UNITED STATES PATENT AND TRADEMARK OFFICE

Office Action Summary

09/874,965

EMEK, MORDECHAY

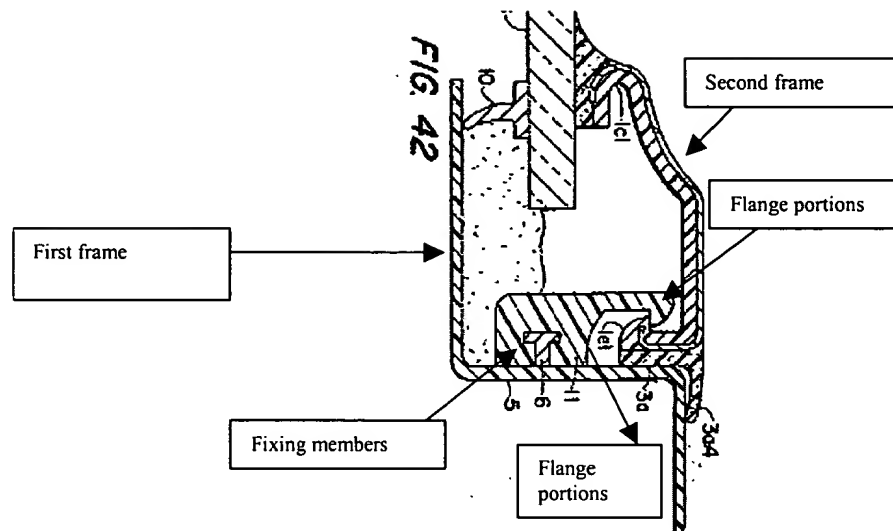
Katoh (figure 42) shows a reinforced window system having a first frame (5) fixable to an opening, the first frame is provided with a plurality of fixing members (11) distributed on an inside perimeter of the first frame, a second frame (see figure below) which is separate from the first frame and is removably installable therein, the second frame carries a reinforced window pane (8) secured within the second frame, the second frame is provided with a plurality of support members (1e1, 3a, 3a4) distributed on an outside perimeter of the second frame to face the fixing members of the first frame and to support the second frame when the support members are in engagement with the fixing members, at least some of the fixing members being provided with a securing means (6) for securing position of the second frame within the first frame, some of the fixing members being removably attached to the inside perimeter of the first frame (means 6 allows removal) the fixing members being provided with flange portions (see below) for engagement with the arm portions (3a, 1e1) of the support members, some of the flange portions of the fixing members being configured as hook-like portions (the top flange portion) adapted for

engagement with the corresponding first arms (1e1) of the support members, some of the flange portions of the fixing members constitute elongated protrusions (bottom flange portion, see above) formed on the inside perimeter of the first frame and the protrusion is directed towards the second arm (3a) of the support members, the second frame member inherently would engage the corresponding flange portions of the fixing members and leans in a radial inward direction when forced by a shock wave and the arm portions of the support members would inherently dissipate the energy of a shock wave striking on the window pane by leaning back and then shearing (the support members would first hook, then yield, and then shear), the fixing members being adjustable and removable (due to the piece 6 which allows the moving and adjusting of the fixing members 11), the window pane being fixed to the second frame by an adhesive (3b, col 2 lines 13-16, col 4 lines 4-7), the window pane (8) is fixed to the second frame by a mechanical glazing system, fitted with resilient gaskets (3b, 10) at both faces of the window frame.

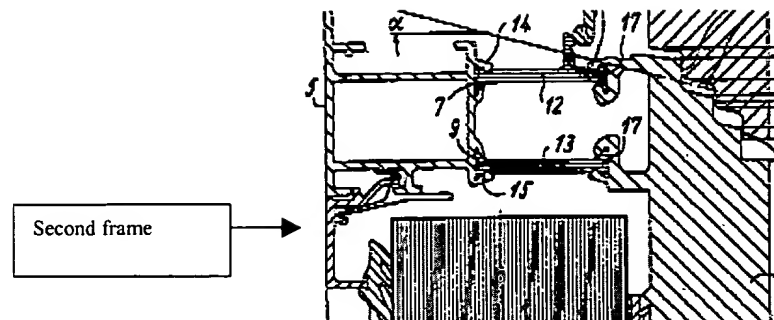
Habicht et al (figure 1, below) shows a reinforced window system having a first frame (comprise of 20, 12, 13, 5) fixable to the opening in a wall, the first frame being provided with a plurality of fixing members distributed on an inside perimeter of the first frame, a second frame

which is separate from the first frame and is removably installable therein, the second frame carries a reinforced window pane (1, how to reinforce is not claim yet) secured within the second frame, the second frame being provided with a support member distributed on an outside perimeter of the second frame to face the fixing member of the first frame and to support the second frame when the support member being in engagement with the fixing members, at least some of the fixing members being provided with a securing means for securing position of the second frame within the first frame, the support members being removably attached to the outside perimeter of the second frame, the support members being configured as bifurcated members having a leg portion attachable to the second frame and an arm portion, extending towards the fixing members of the first frame and engageable therewith, the arm portion comprising a first and second arm, the support member being fixed at their locations

to the second frame, the window pane (1) sealingly bears against the first frame, a width dimension defines the support members and the adjacent support members provided with different width dimension, the system being a fool-proof system whereby the fixing members of the first frame and the corresponding support members of the second frame being distributed along respective inside and outside perimeter of the second frame and the first frame such that the fixing members extend opposite corresponding support members only at a correct mounting of the second frame within a first frame.

Habicht et al does not show the support member being a plurality of support members.

It would have been obvious to one having ordinary skill in the art at the time of the invention to modify Habicht et al to show the support member being a plurality of support members because having a plurality of support members would enable the supporting of a large frame.
